STAFF REPORT

Meeting Date:	March 19, 2025	Meeting Title:	Planning Commission
Submitting Department:	Planning Department	Presenter:	Tyler Valentine
Agenda Item:	Sketch Plan for a +/-190,000 sf (habitable) mixed-use hotel and condominium development within five buildings along North Cache at the 11 properties listed below (P24-170)	Public Comment:	Yes

SITE PLAN

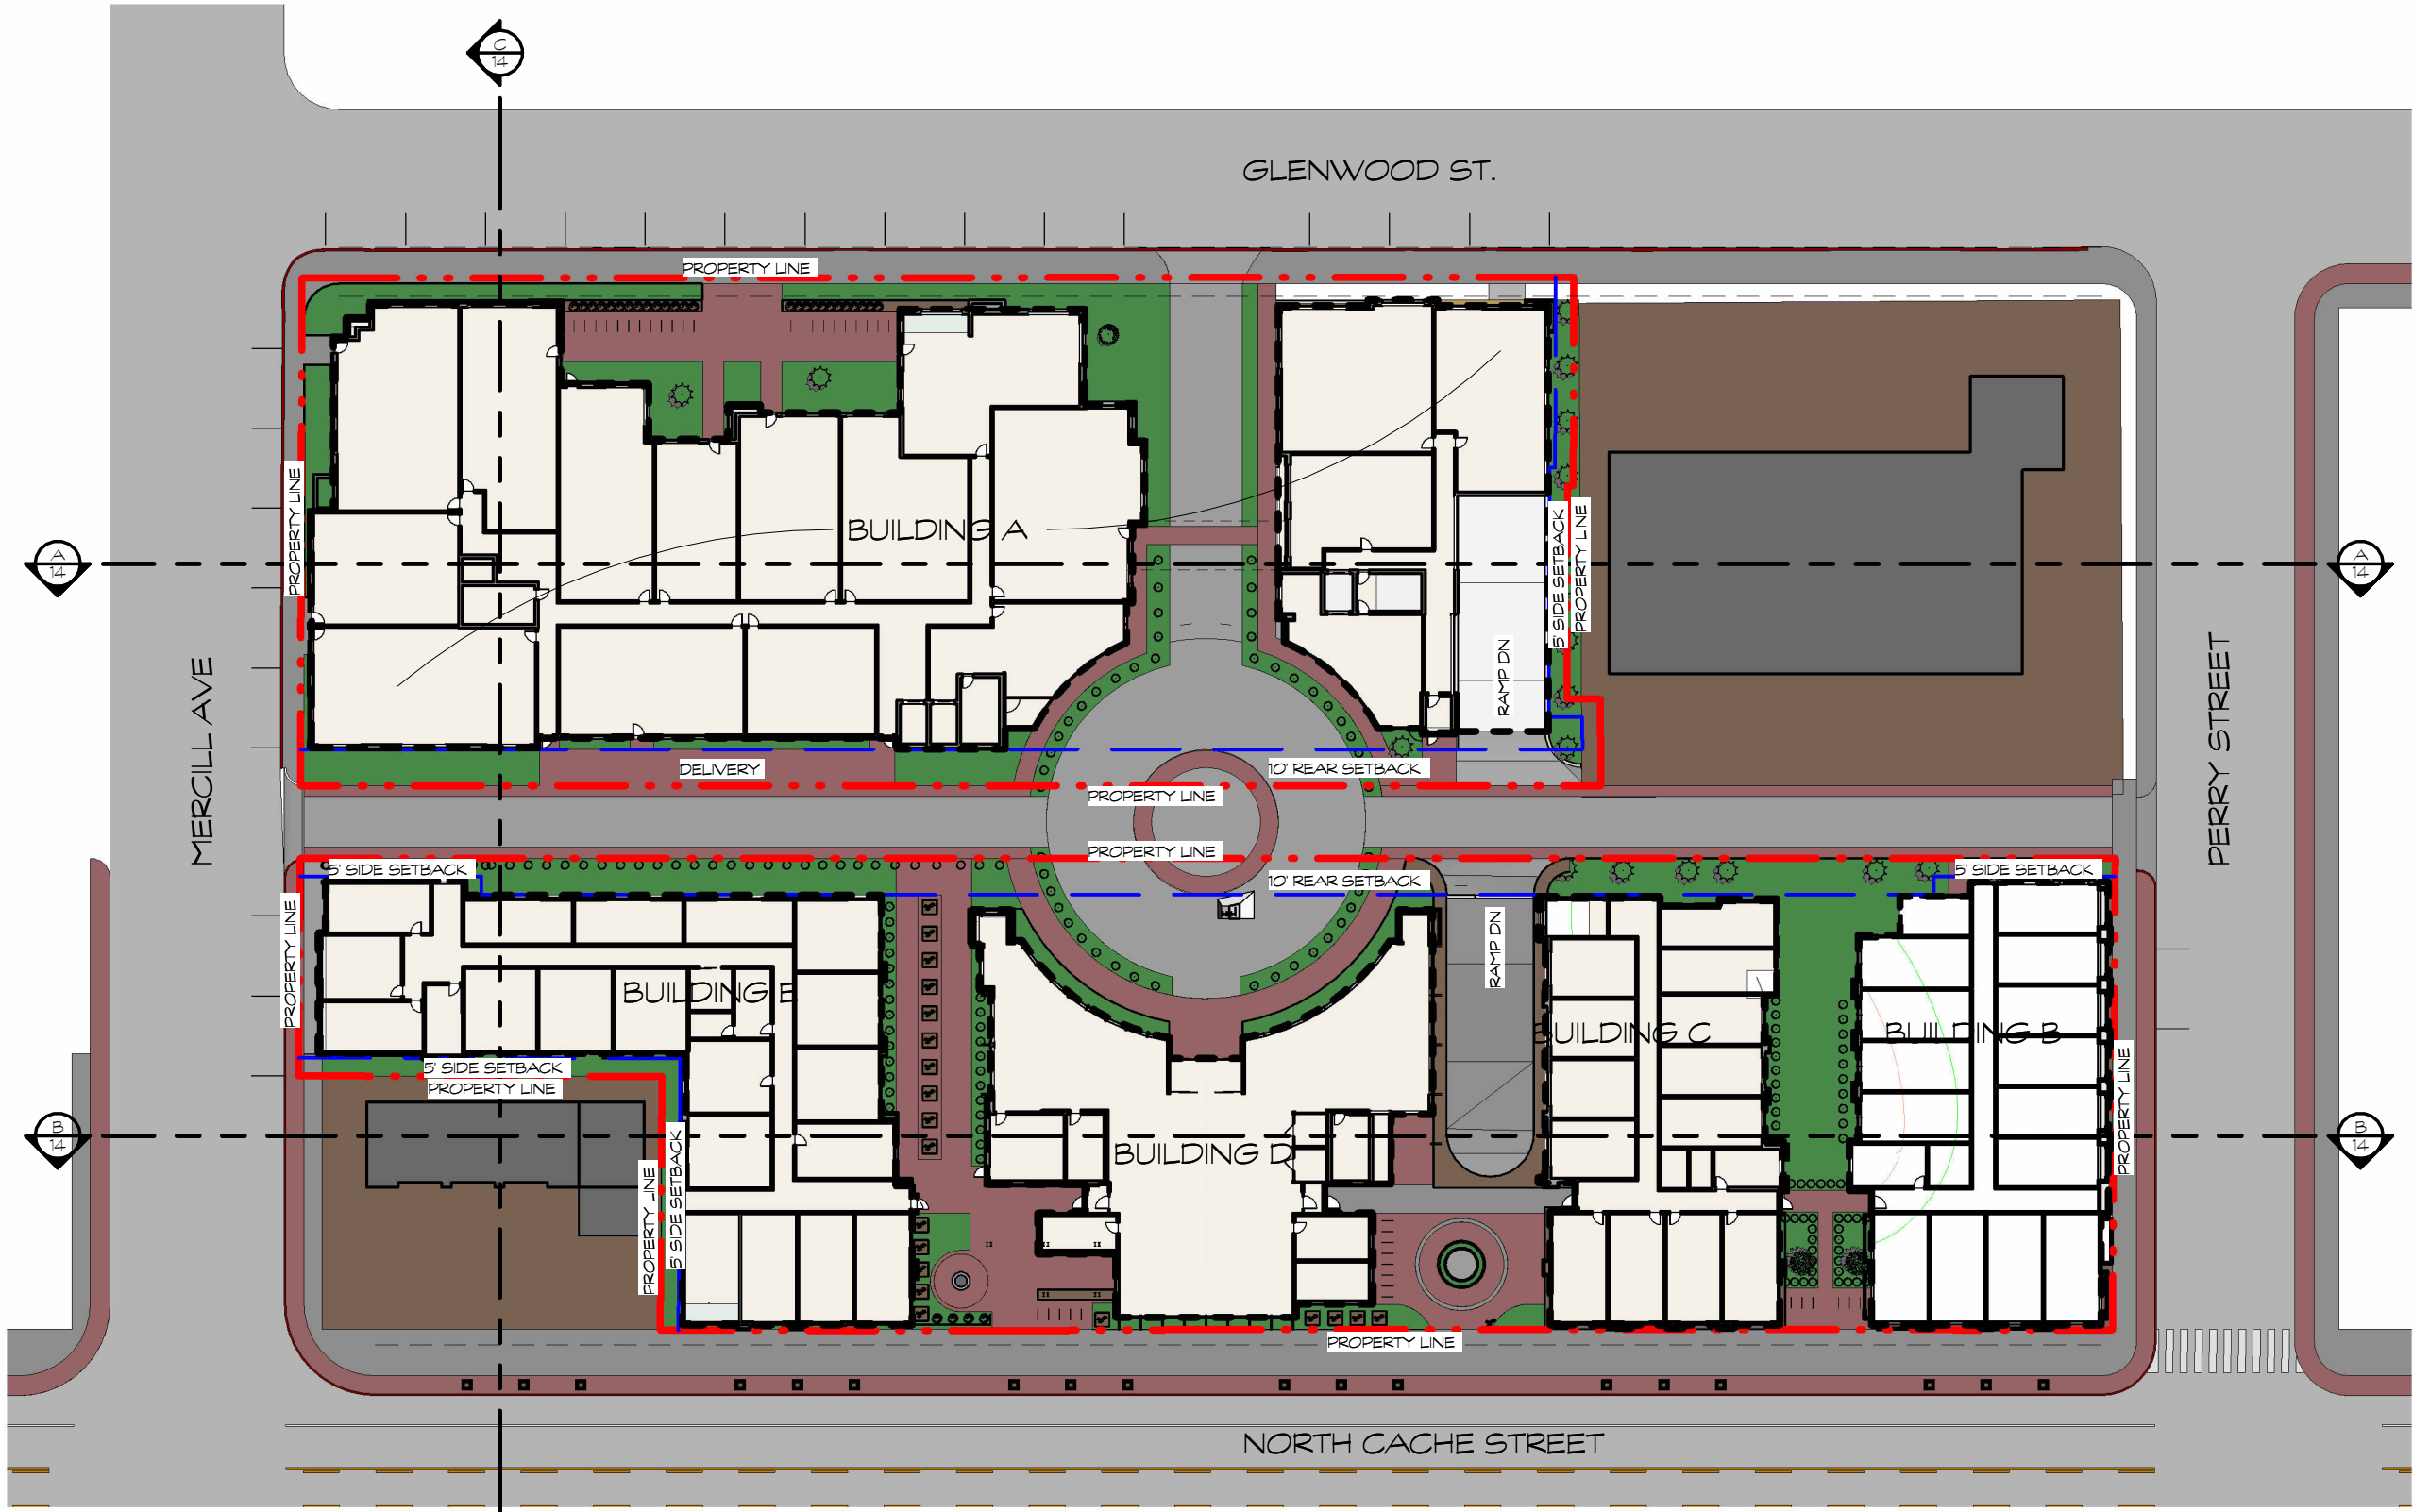
- Conceptual-level bike parking – The applicant has shown a conceptual level bike parking plan with long-term storage in both parking garages and short-term parking near the main entrances on both sites. Please refer to Sheet 6 – Site Plan and Sheet 8 – Basement Plan in the applicant’s submittal.
